**Albion Park Quarry
Stages 5 and 6 Modification
(LEC Consent No. 10639 of 2005 MOD 3)**

**Environmental Assessment Report
Section 75W of the *Environmental Planning and Assessment Act 1979***

Figure 3: Staging Plan

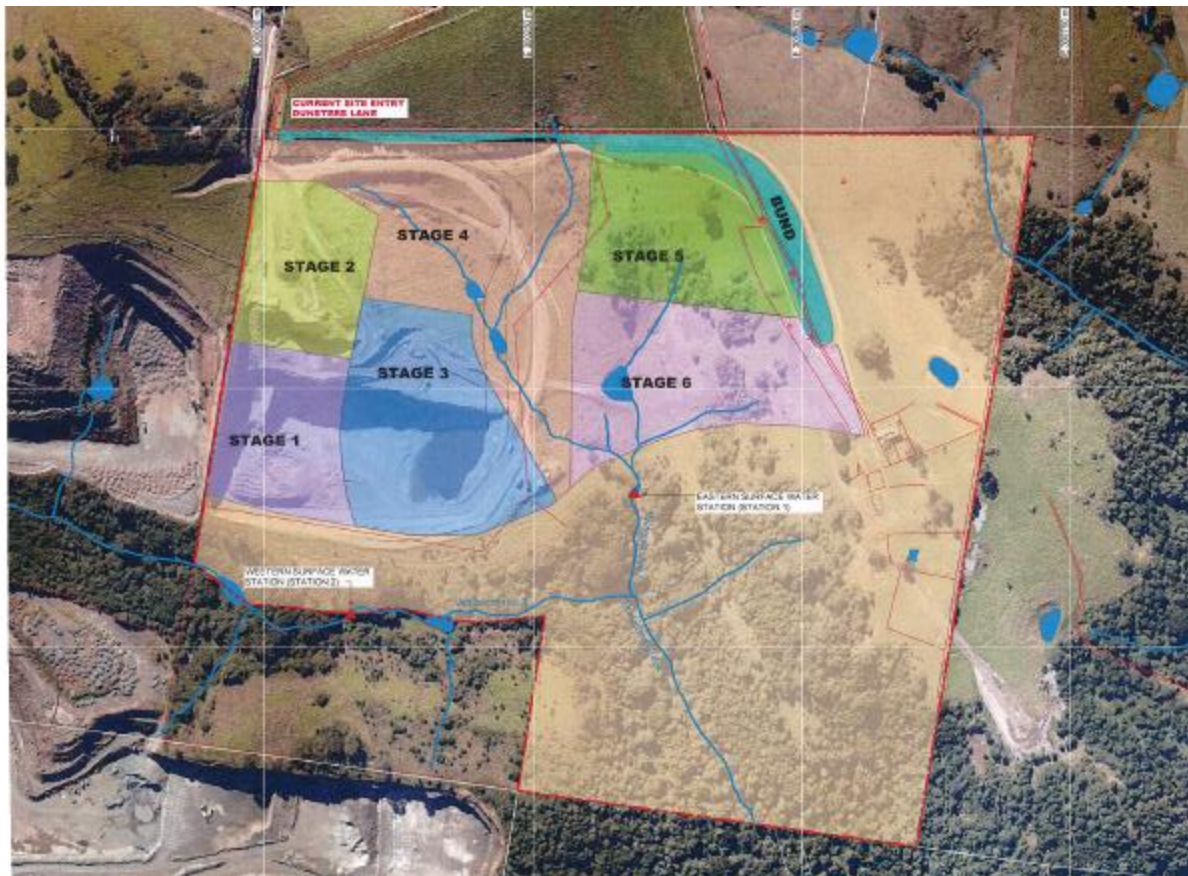
Following the commencement of Stage 1, a 3 metre (m) high vegetated bund was constructed along the north-eastern boundary of the extension area to provide visual and acoustic protection for the key receivers (see **Figure 3**). Since the commencement of Stage 1, noise monitoring has been conducted at three of the four receiver locations ('The Hill', 'The Cottage' and Greenmeadows Estate). This monitoring data indicates that noise levels generated at the quarry have remained within the limits specified in **Table 3**.

<i>Visual Amenity</i>	- Potential visual impacts to the east, south and west are limited as affected properties are quarry-owned. - Views from the north and north-east have been screened by the existing earth bund (see Figure 3).	- Existing conditions require Cleary Bros to maintain the bund, and minimise the visual impacts of the development to the satisfaction of the Secretary. This could include, for example, additional screening of the approved dwelling at Fig Tree Hill, if it is built. - The Department is satisfied that the visual impacts of the proposed modification would be minimal and suitably managed under existing conditions.
<i>Biodiversity</i>	Selected areas of the site are identified as 'Environmentally Sensitive Land' (ESL) under the <i>Shellharbour Local Environmental Plan 2013</i>.	The Department is satisfied that the proposal's biodiversity impacts would be minimal and
